Form 3160-5
(June 2019)UNITED STATES
DEPARTMENT OF THE INTERIOR
BUREAU OF LAND MANAGEMENTFORM APPROVED
OMB No. 1004-0137
Expires: October 31, 2021**SUNDRY NOTICES AND REPORTS ON WELLS**
Do not use this form for proposals to drill or to re-enter an abandoned well. Use Form 3160-3 (APD) for such proposals.5. Lease Serial No. **NMNM119276**

8. Well Name and No. **MODELO 10 FED COM/509H**9. API Well No. **30-025-50940**10. Field and Pool or Exploratory Area
Triste Draw; Bone Spring11. Country or Parish, State
LEA/NM**12. CHECK THE APPROPRIATE BOX(ES) TO INDICATE NATURE OF NOTICE, REPORT OR OTHER DATA**

EOG respectfully requests an amendment to our approved APD for this well to reflect the following changes:

Modelo 10 Fed Com 744H (FKA 509H) API #: 30-025-50940

Plan #0.1 RT

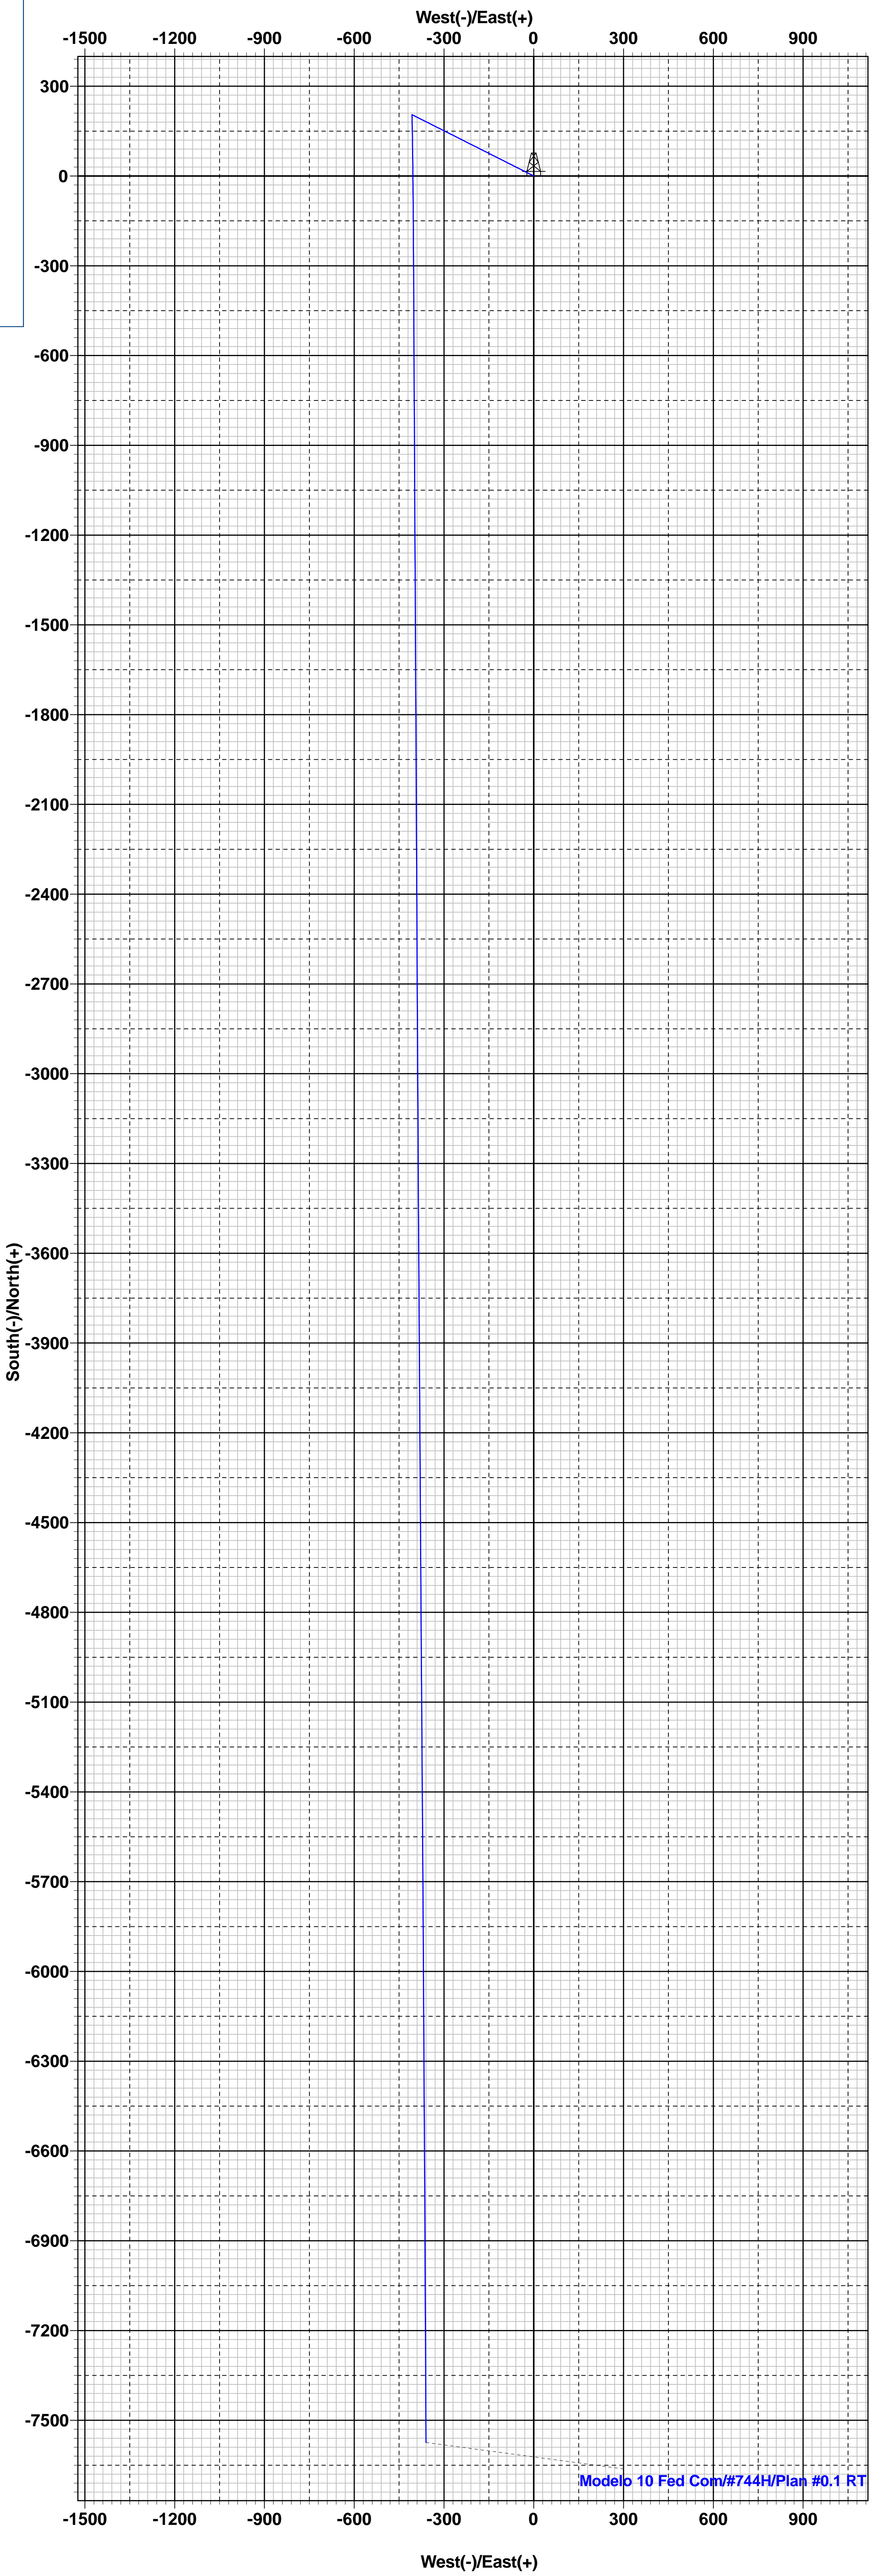
Change target formation to Wolfcamp U4.

Update casing and cement program to current design.
